**RE: Sandia Area Credit Union and Starbucks, 11301 Montgomery Boulevard
Grading and Drainage Plan
Engineer's Stamp Date 7-01-2015 (File: F22-D002)**

**RE: Grading and Drainage Plan
F22-D002
Sandia Area Credit Union**

REVISED
DRAINAGE REPORT

**SANDIA AREA FEDERAL CREDIT UNION/STARBUCKS
11301 MONTOMERY NE
Albuquerque, New Mexico**

DETAIL A

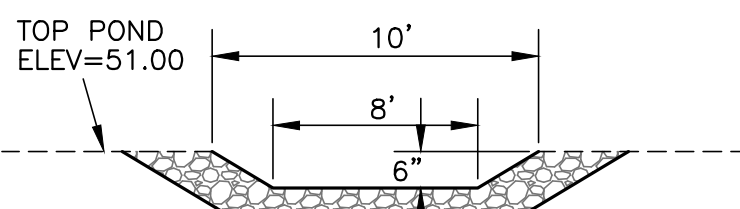
5. We have added the orifice plate detail and labeled.
6. We have revised the detail in the report, we have single and doubles, also the layout was alternated to have 45 degree bends, the west tank is the tank for cleaning so we had to connect as shown

TO BE INSTALLED @ THE OUTFLOW
OF THE CATCH BASINS (SEE THIS PLAN
FOR ORIFICE PLATE SIZES)

9" DIAMETER ORIFICE
INVERT=39.50
AT 12" PIPE CONNECTION

OVERFLOW CROSS SECTION

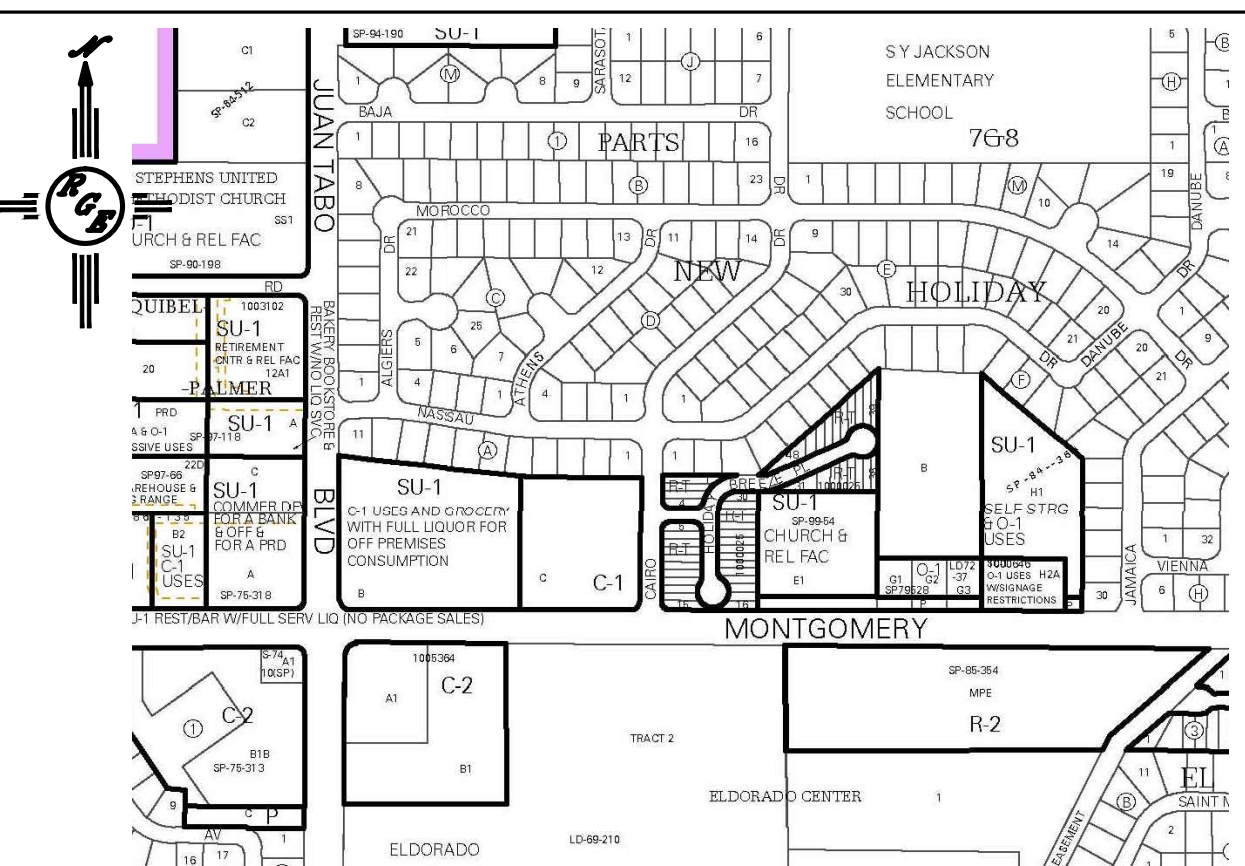
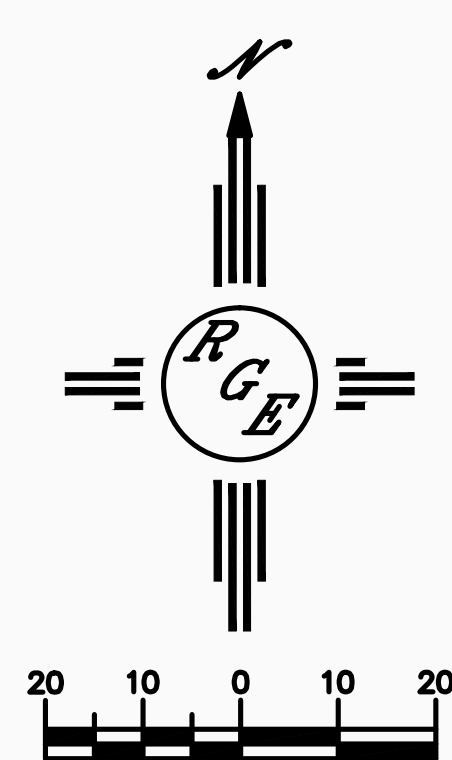
8. We included the pictures and file number
We are worried about draining next to a retaining wall we have stopped the sidewalk culvert short so the first flush flow is captured by a harvest trench and spills out a 2' opening as before.

10' WIDE TOP /
8' BOTTOM, 6" DEEP
INV. OUT=50.50
EMERGENCY OVERFLOW
1' THCK FRACTURED ROCK
6" AVERAGE SIZE
